NATIONAL CAPITAL DESIGN REVIEW PANEL

Block 16 Section 10 City – Second Session
70 Allara Street

Project: 70 Allara Street

Review date: Wednesday 14 July 2021

Built Form alignment

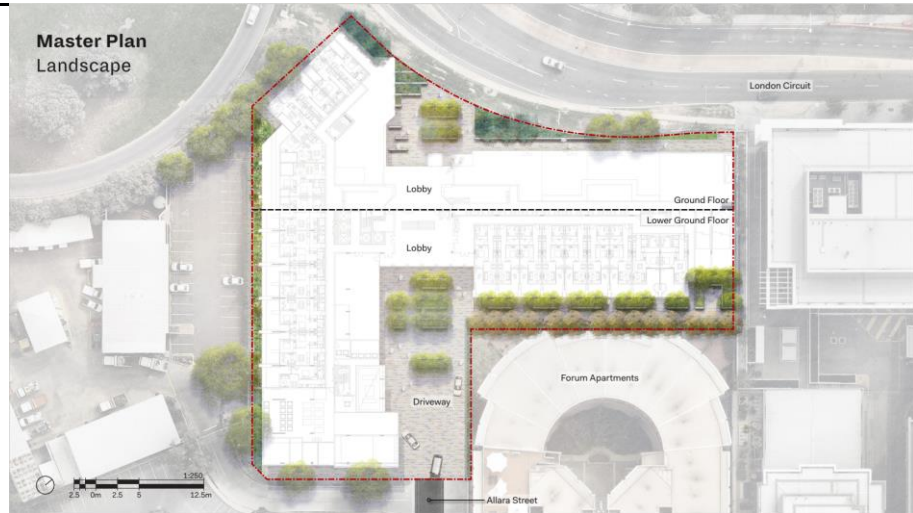
1.2 The amended building alignment proposed is acknowledged by the Panel as an improvement from the initial proposal, however, the Panel considers further design development is required to address the single large footprint of the proposal (see 4.1) and the current distortion of the London Circuit geometry to the west of the site. This may include

reconsideration of the alignment of the 'Jewel' building to align with the London Circuit southern edge geometry and division of the proposed connected building forms on the site.

In reconsideration of the alignment of the 'Jewel' as suggested above, London Circuit is given primacy over the secondary the side road that will provide a future connection to Parkes Way and therefore the building alignment is retained in its current position, parallel to the tangent of London Circuit. This alignment provides for:

Landscape Plan

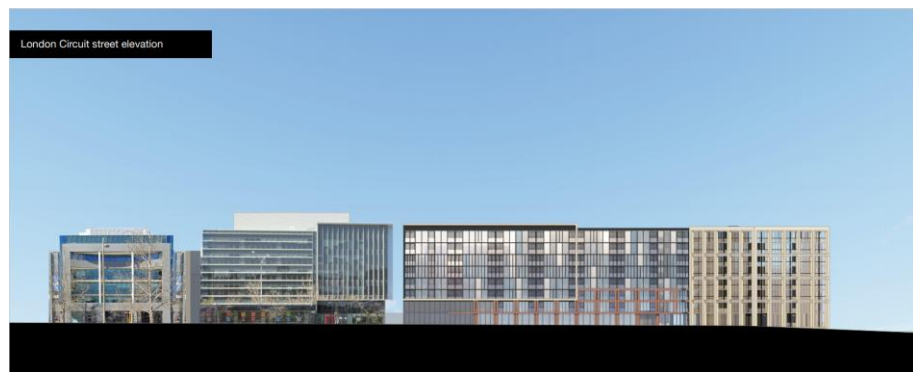
- 2.1 The landscape proposal as presented is considered by the Panel to illustrate an enticing outcome for the development however concerns regarding the character, bulk and scale of the civic spaces were expressed by the Panel. The proponent team is therefore encouraged by the Panel to consider how integrated external spaces could be better accommodated within the site. This may include division of building forms and alternate building articulation arrangements to facilitate generous courtyards spaces consistent with the inner courtyard typology characterised throughout this part of the city. The Panel therefore looks forward to seeing further development of the detailed landscape proposal at the next design review session.

- 2.2 The inclusion of deep root soil zones for large canopy tree planting to London Circuit and the Forum Apartment interface is acknowledged by the Panel. As the proponent team continues to develop the proposal, the Panel recommends a greater emphasis be placed on providing deep soil zones in key spaces such as public and communal courtyards.

Further review of the building form has led to exploring opportunities where the ground floor landscape could be extended to create courtyards.

Deep soil planting has been maintained within the previously nominated areas along London Circuit and at the interface to the Forum Apartments. The updated proposal now includes additional deep soil planting within the eastern courtyard on the Ground Floor (off London Circuit).
